PARTS & SERVICE NEWS

REF NO.	AT00281
DATE	Feb. 2, 2001

SUBJECT: REPAIR TO IMPROVE WATERPROOF-ABILITY OF T/M CONTROLLER MOUNTING SECTION ON WA200/250-3

3. Contents of the modification

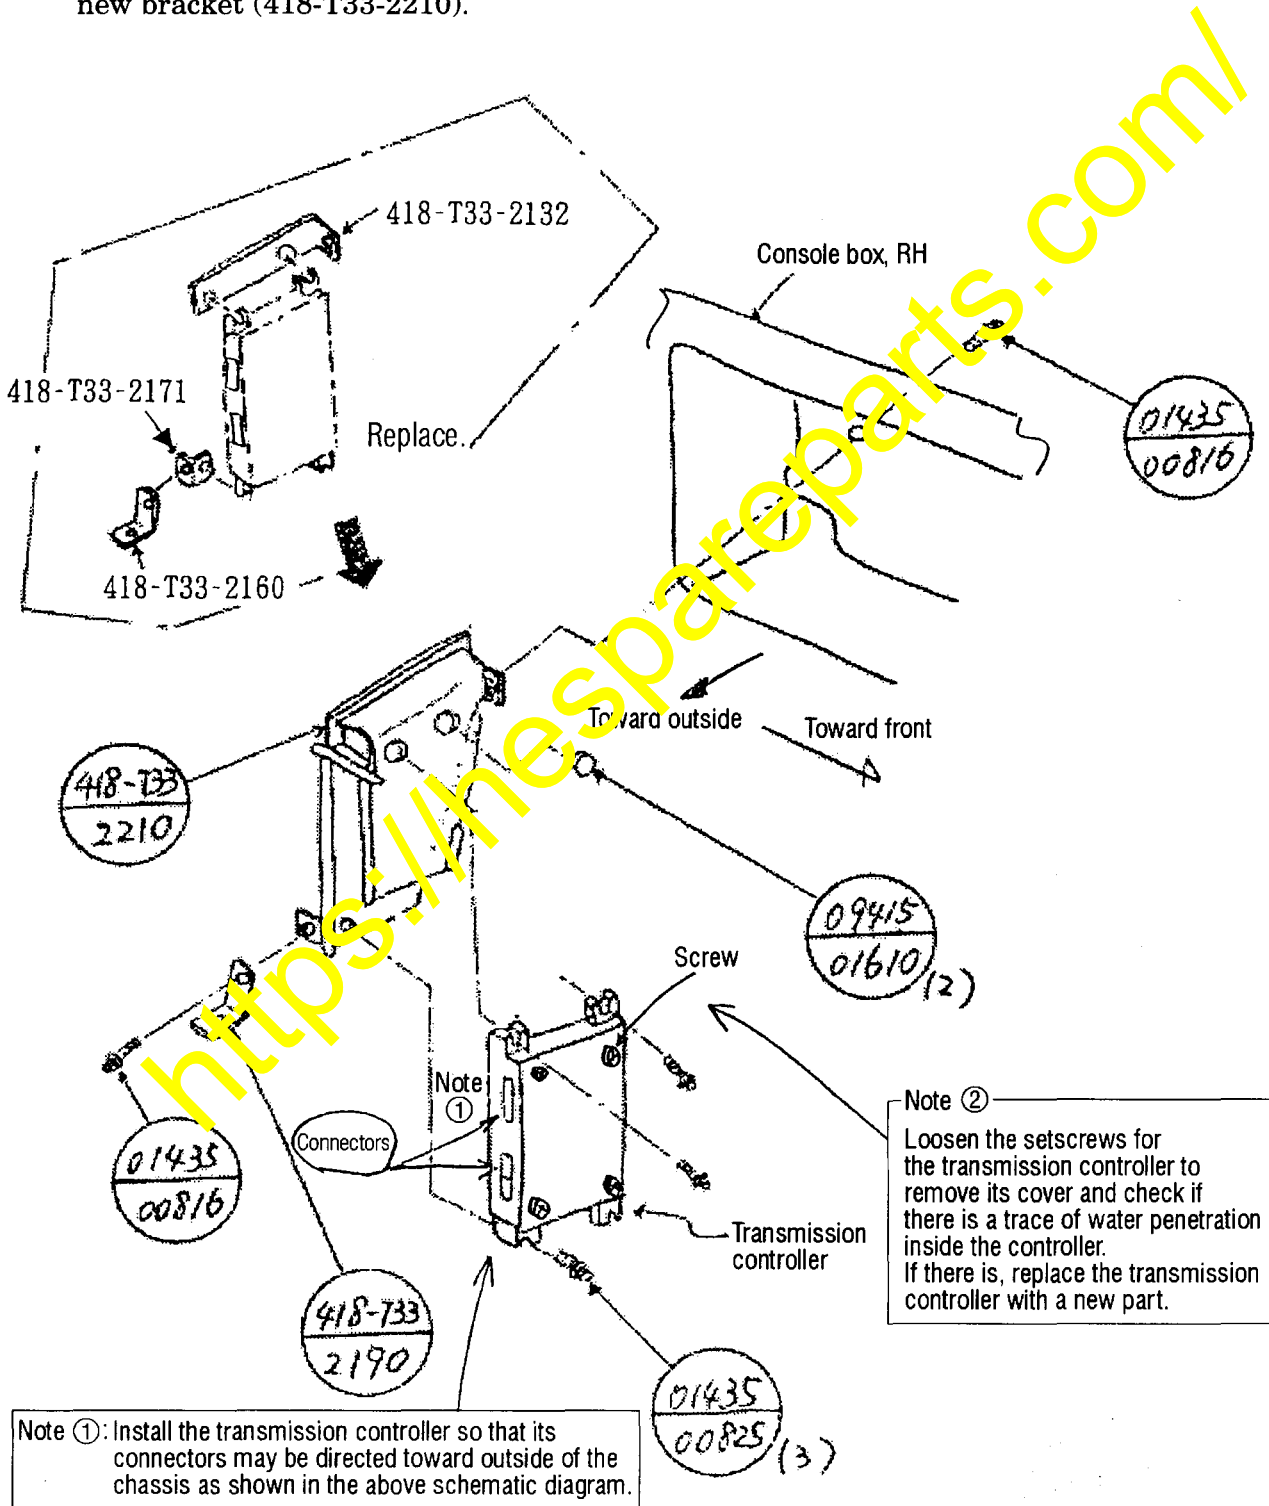
The water proofing capacity has been improved by the following modifications

- (1) The shape of the transmission controller mounting bracket has been changed into a drip-proof type.
- (2) A seal has been supplemented to the sub-monitor cover.

According to the instructions given in the schematic diagrams indicated below, replace the transmission control bracket located inside the RH console box with the prepared new bracket (418-T33-2210).

Apply the prepared supplementary seal to cover the opening of the sub-monitor as shown in the schematic diagrams indicated below.
